Addendum Number 3

Lake Peachtree Spillway Replacement Project

August 4, 2017

A SEGMENT I1 DOWNSTREAM RAMP SECTION
SCALE: 3/8"=10'

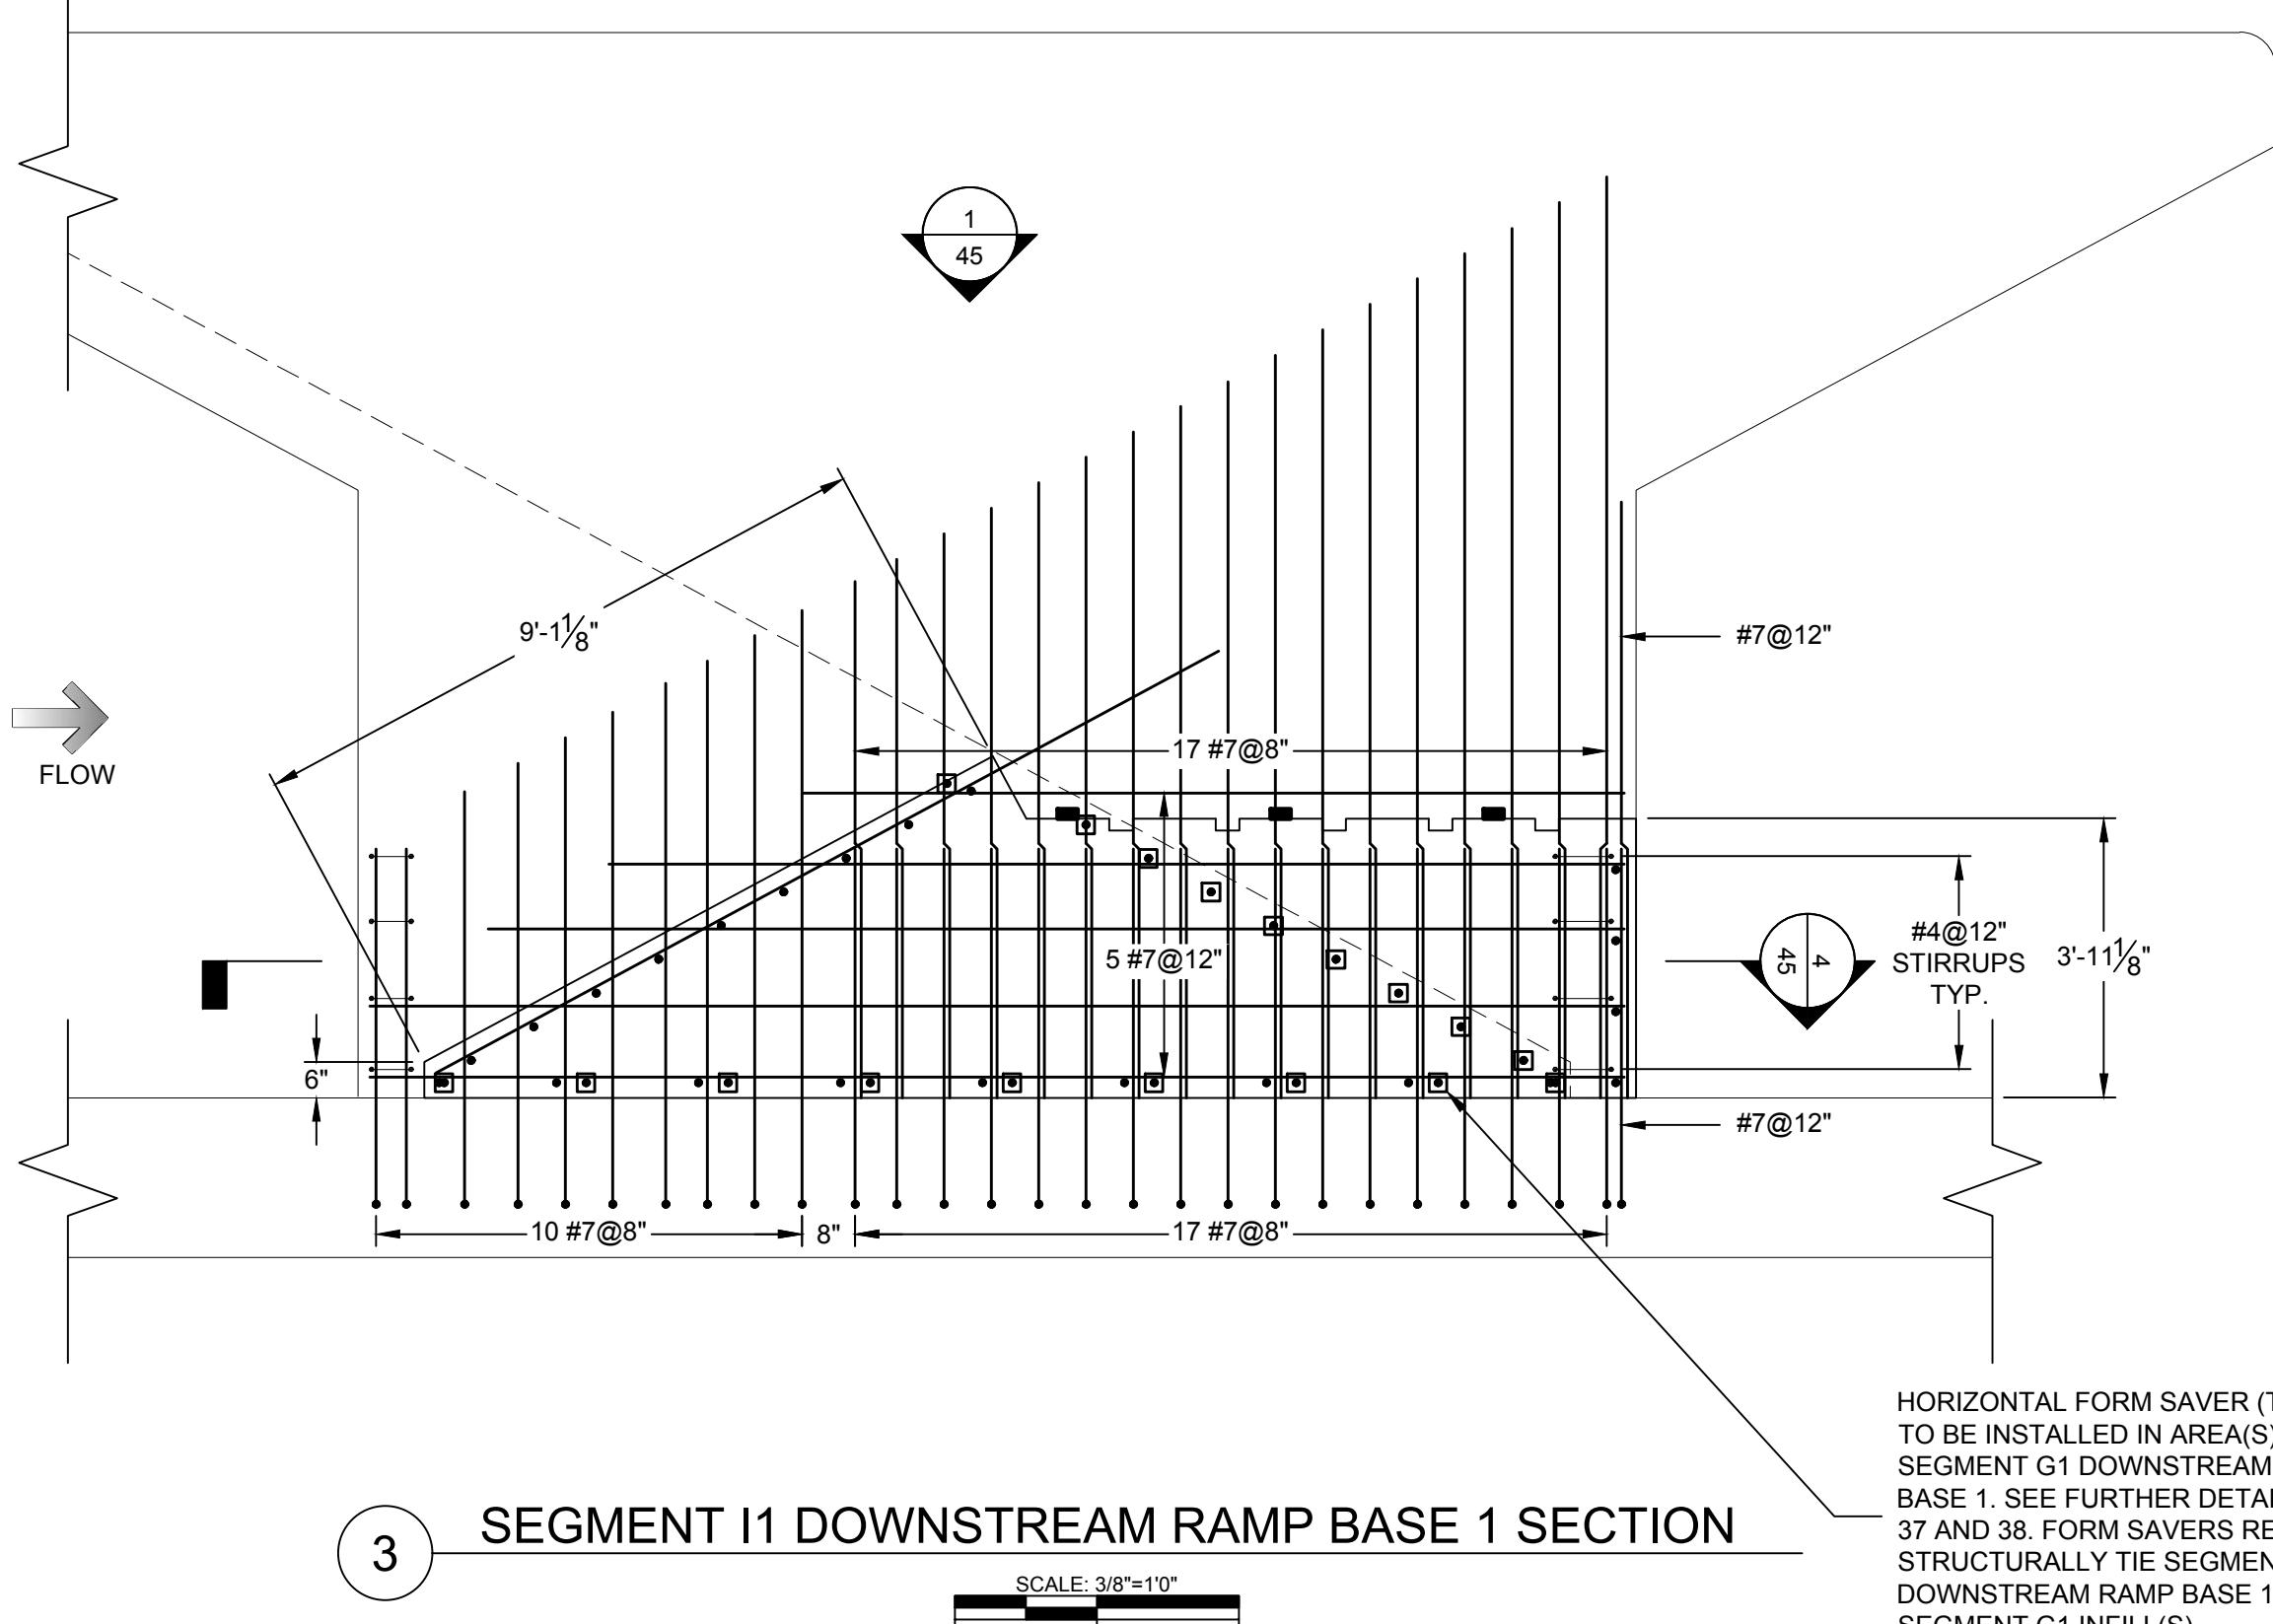
- a. The dimensions shown on the section view are correct. An updated sheet depicting the bridge dimensions is appended for your convenience.
5. (Reference: Plan Sheets 33, 40, 43, 44) Please provide depths for the upper cut-off walls for slab sections G1, G2, H1, H2 and I1. Also provide rebar configurations for these walls.

- a. The depth of the upstream cutoff walls is 6 and one-half feet below the slab subgrade. The reinforcing steel is shown on the revised sheets.
6. Please confirm that Bid Item 16c, "Slab Concrete" includes construction of slabs A1 through I1, all inlet/outlet wing wall slabs and all cut-off walls beneath these slabs.
